Subject: AIR TEMPERATURE WILL NOT CHANGE	Bulletin No: 07-003/15
	Last Issued: 11/17/2015

BULLETIN NOTE

2014-15 Mazda3 (Japan built with manual A/C) with VINS lower than JM1BM*****247593 (produced before December 1, 2014)

2014-15 Mazda3 (Mexico built with manual A/C) with VINS lower than 3MZBM*****182009 (produced before January 1, 2015)

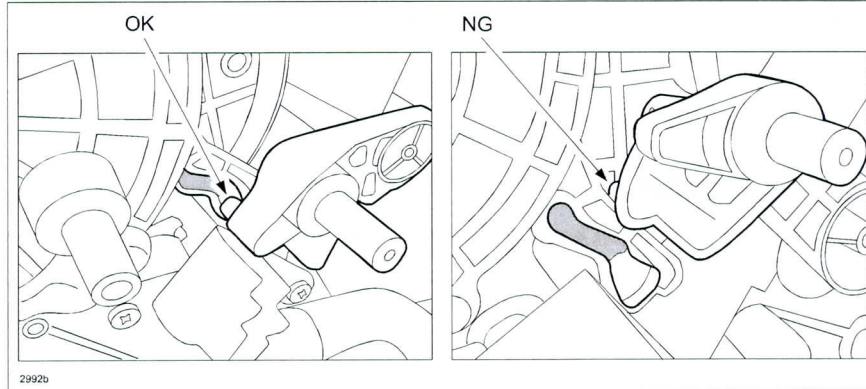
Some customers may complain about that air temperature from the air conditioner will not change by the air temperature control knob, and may be accompanied by some rattle noise from inside of the dash board. This concern may be caused by the temperature control link being pulled out of the HVAC housing. To correct the problem, the temperature control link has been modified.

1. Verify customer concern.
2. Refer to the instructions on MS3 online or the Workshop Manual (section 07-40 CLIMATE CONTROL UNIT REMOVAL/INSTALLATION [MANUAL AIR CONDITIONER]) and check that the MIX LINK (Air mix link/Temperature control link) (A) is properly connected to the MIX DOOR CRANK (B) and works while rotating the temperature control knob.

- a. If it works, this Service Bulletin does not apply. Refer to the instructions on MS3 online or Workshop Manual for troubleshooting and repair.
 - b. If the MIX LINK is detached, proceed to the next step.
3. Replace the MIX LINK with a modified one. Refer to MS3 online or the Workshop Manual (section 07-11 A/C UNIT DISASSEMBLY/ASSEMBLY). Make sure that the MIX LINK is fitted in the groove of the MIX DOOR CRANK and will not come out with movement.

4. Install the parts in the reverse order.
5. Verify repair.
